02-13-23 FAMILY DOLLAR - BROADHEAD, WI

Issue Name : RTU-2 Motor Sheave Frozen.

SheaveFrozen.jpeg

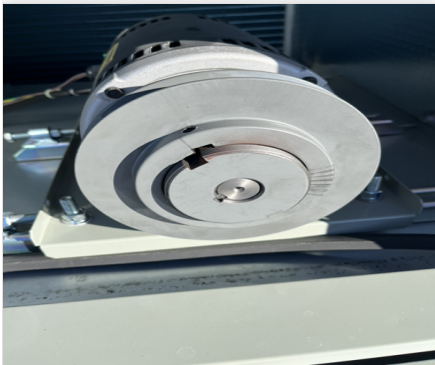
Description : RTU-2 motor sheave was found spun in on itself to 0 turns open. A key and set screw were not found installed, and the pulley could not be loosened free. Recommend pulley is serviced and sheave is set to 1 turn open.
